Lower Yonge Precinct

Municipal Class Environmental Assessment Study
Consultation Summary from the Public Information Centre

Harbour Street: Freeland Street - Lower Jarvis Street (Facing East)
3 - Lane + Bi-Directional Cycle Path + Parking Lane (27.00m R.O.W.)
PRELIMINARY PREFERRED

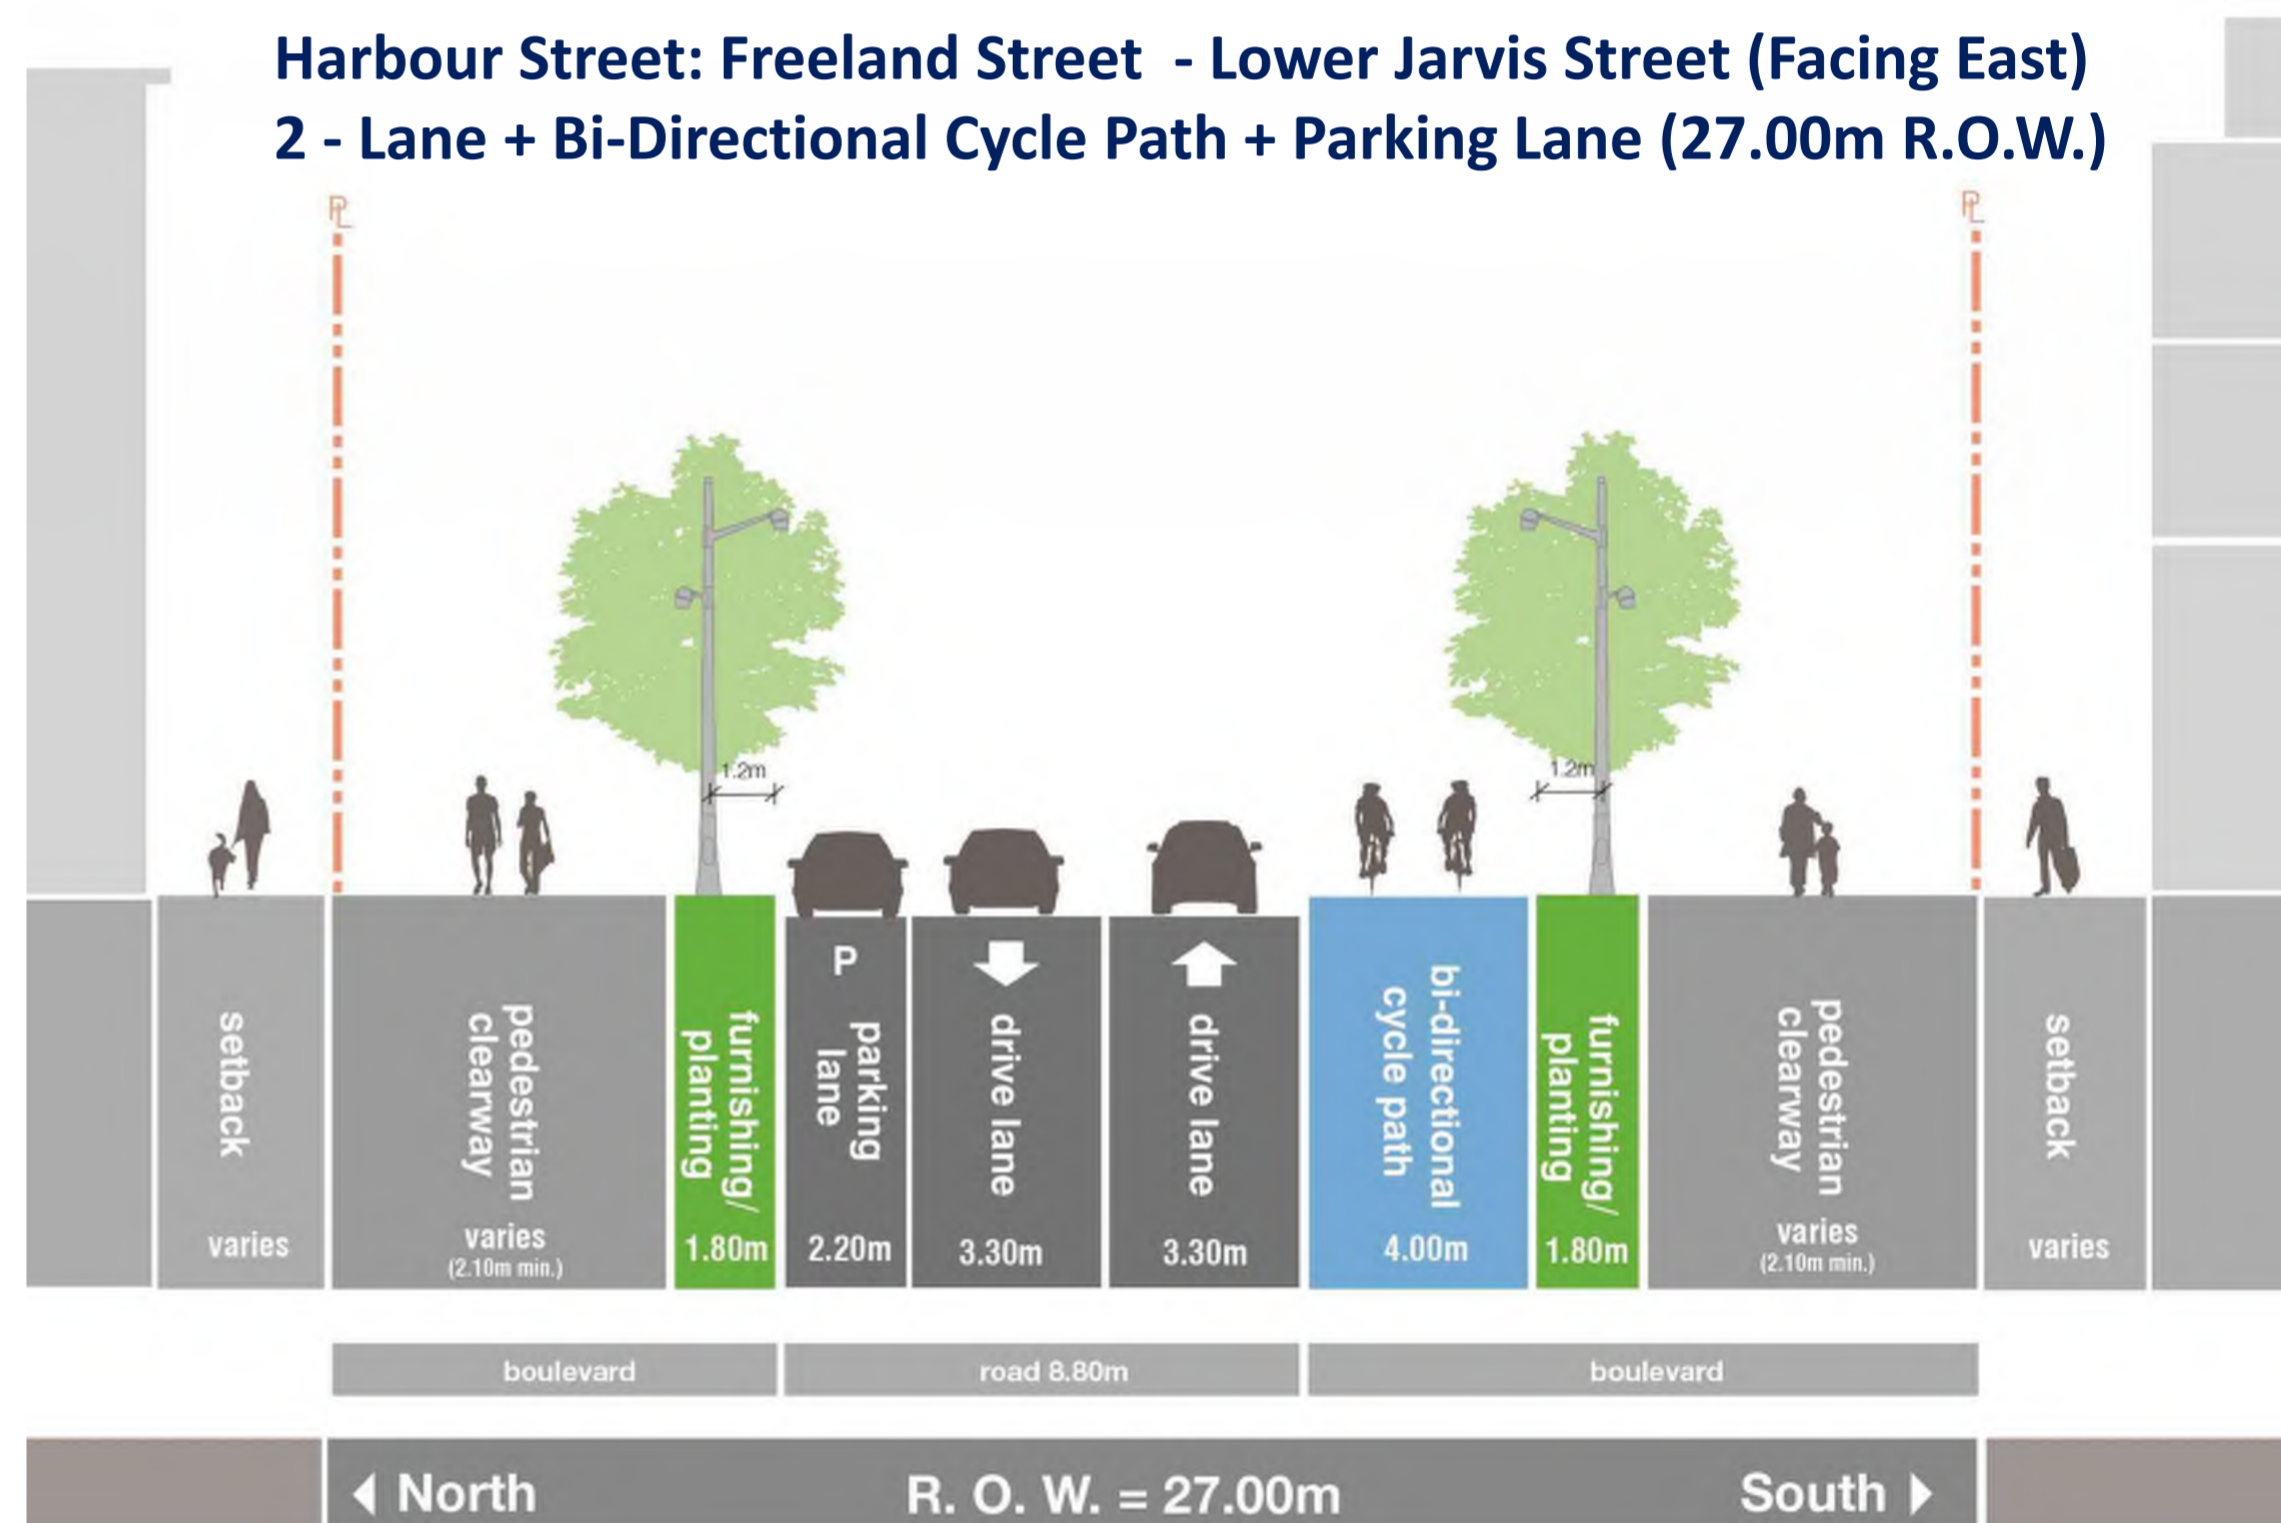
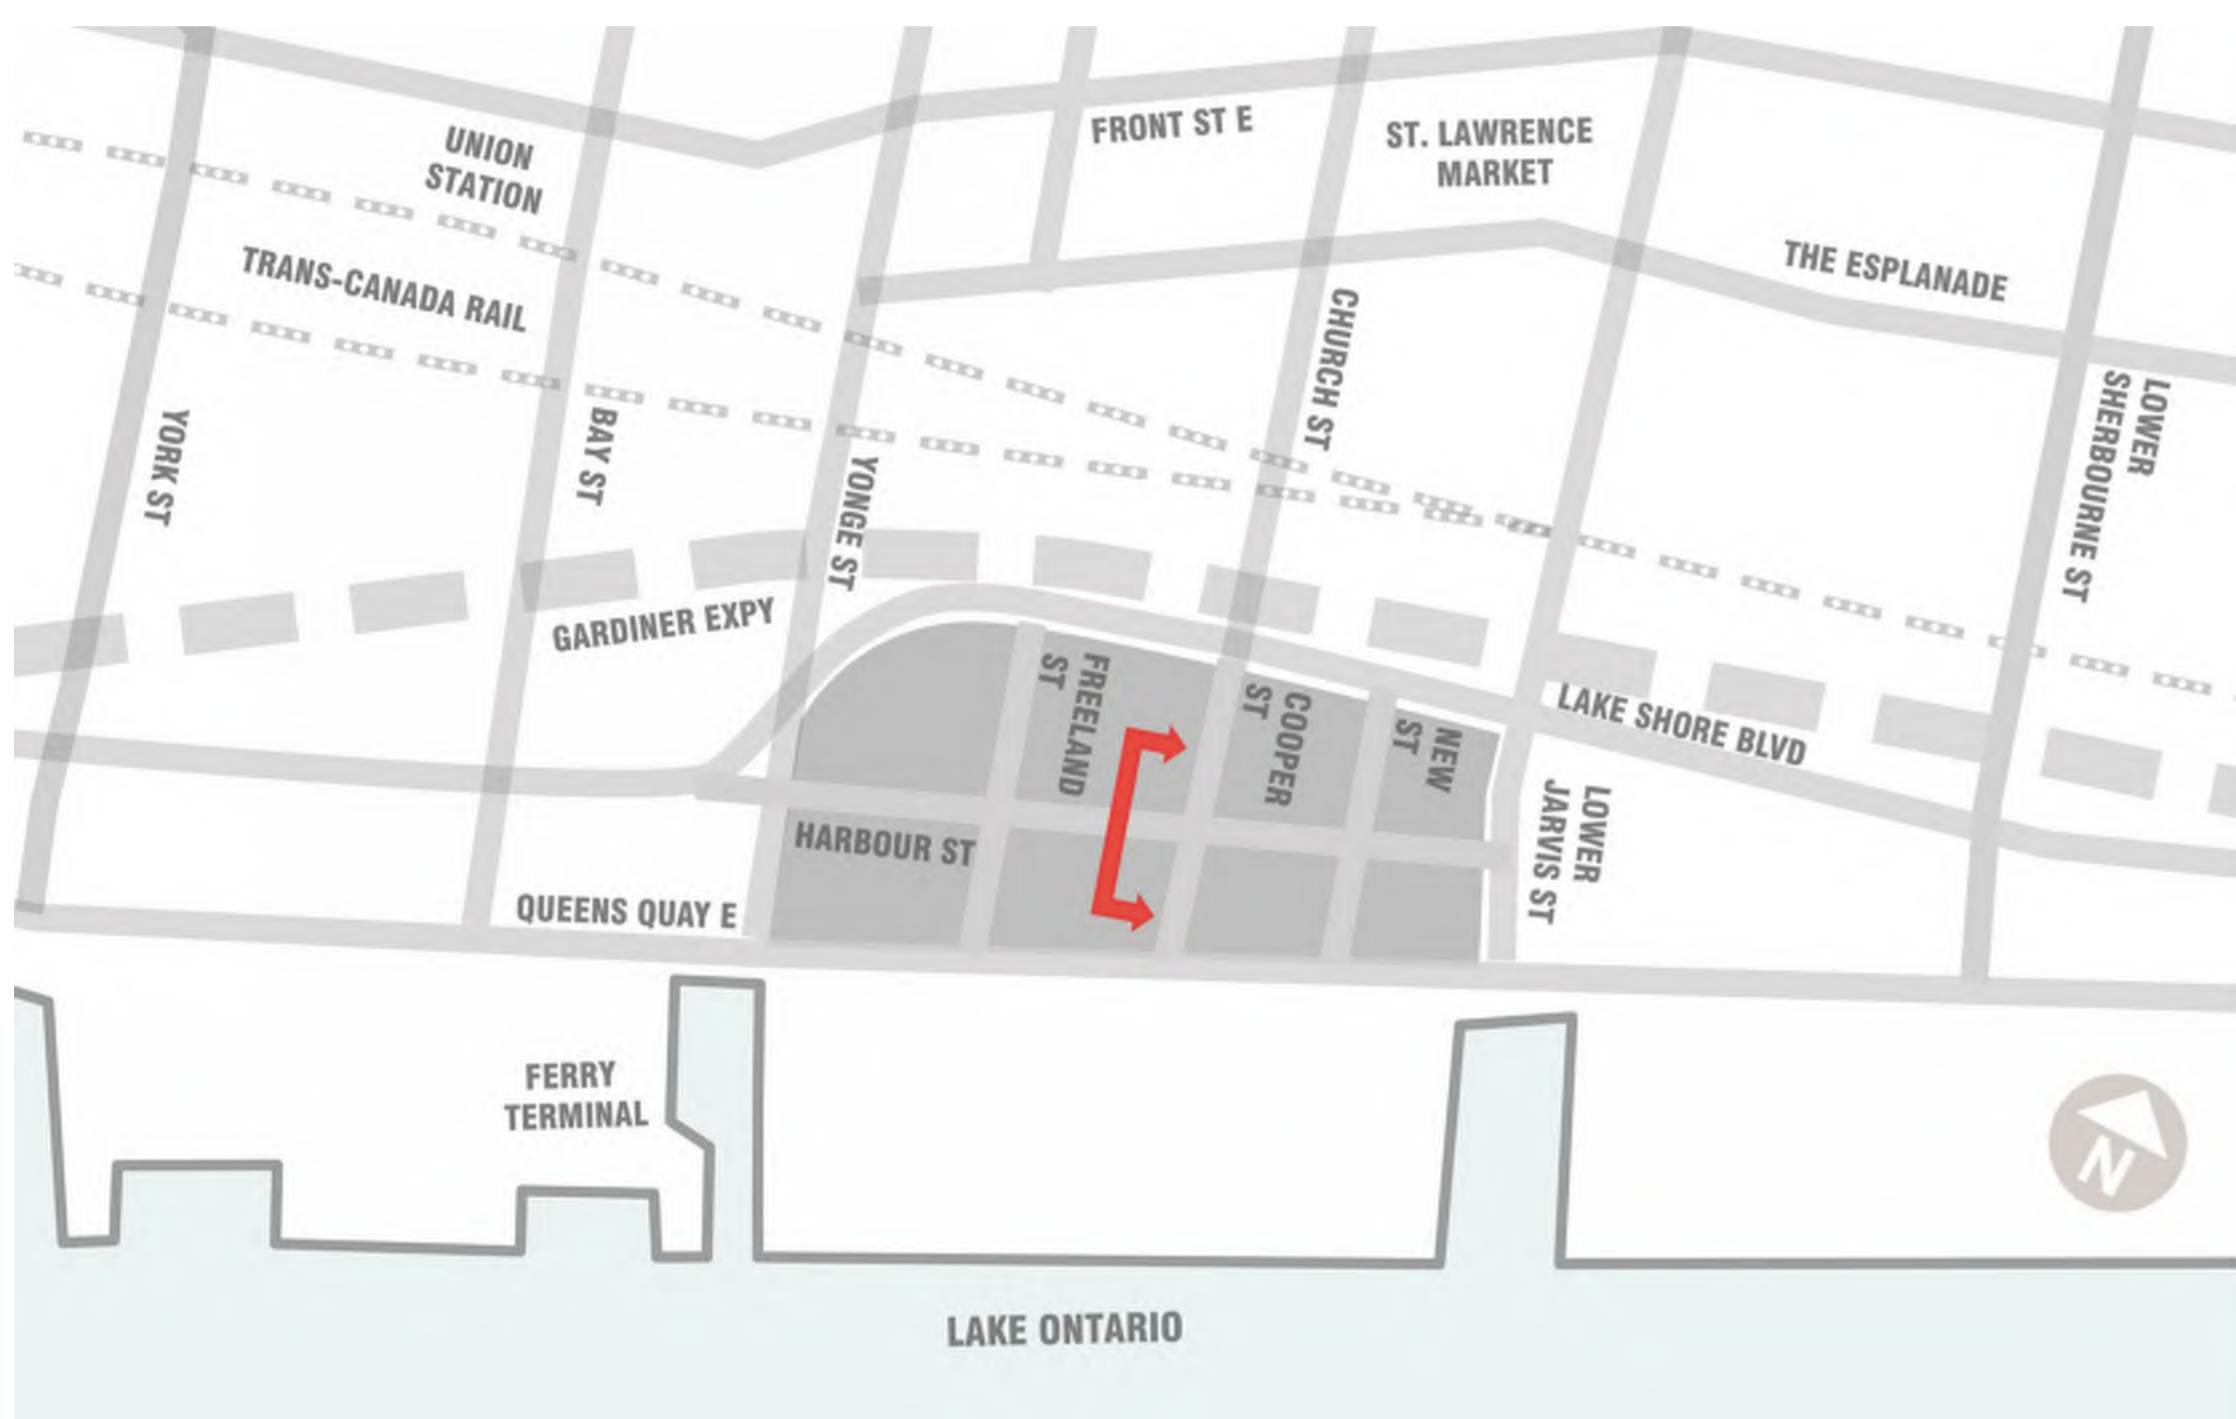
There is no building setback along Harbour Street from Yonge Street to Lower Jarvis Street. Edits will be made to the cross sections to correct this.
